Item 3.**Section 4.55 Application: 100 Bayswater Road, Rushcutters Bay - D/2012/939/K**

File No.: D/2012/939/K

Proposal Summary: S4.55(2) modification for the consolidation of six ground floor apartments into four apartments and the consolidation and replacement of six wintergardens to four ground floor external terraces. Modifications also include changes to ground floor fenestration on the northern elevation, replacement of glass wintergarden roofs with awnings, changes to level 5, 6 and 7 roof finishes from synthetic turf to river pebbles and metal sheeting, a revised lobby design, lobby glazing, driveway amendments and landscape amendments.

Figure 26: Section CC, demonstrating typical proposed terrace proximity and sight lines to neighbouring Marina One apartments

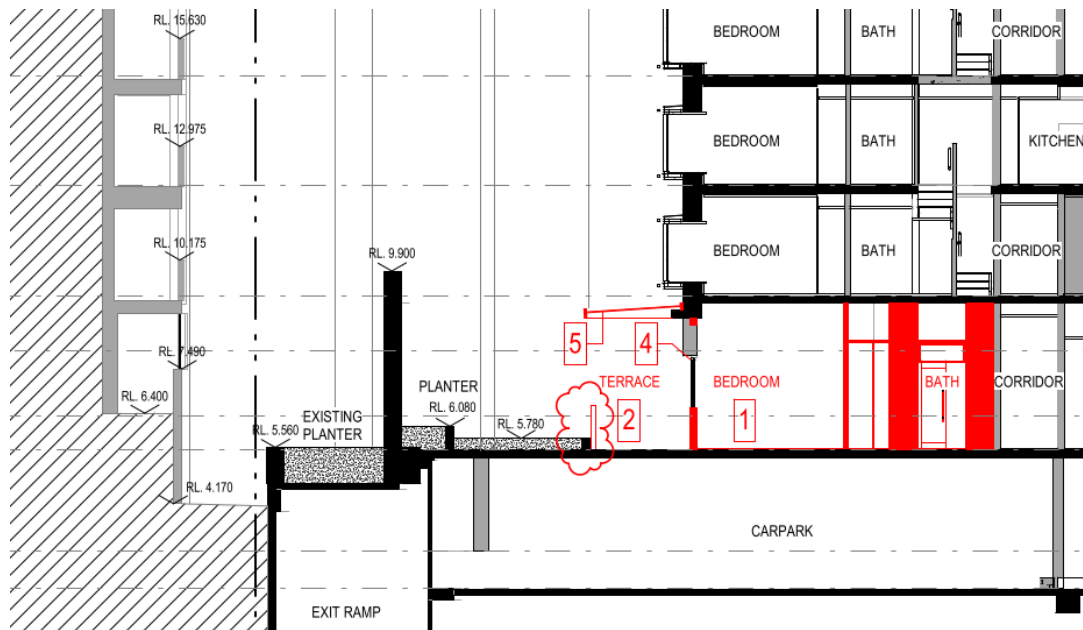
- (c) **Issue:** The proposed terraces will incur visual privacy impacts to the Marina One apartments.

Response: The proposed terraces are set below the adjacent Marina One apartments and are also located behind a 4 to 5 metre tall concrete wall. The proposal therefore does not present any privacy impacts to the neighbouring building. Conversely, the subject terraces are afforded privacy from the neighbouring building by the same built form elements, and the proposed awnings. A section which shows the typical relationship of the proposed terraces to the neighbouring building is provided below.
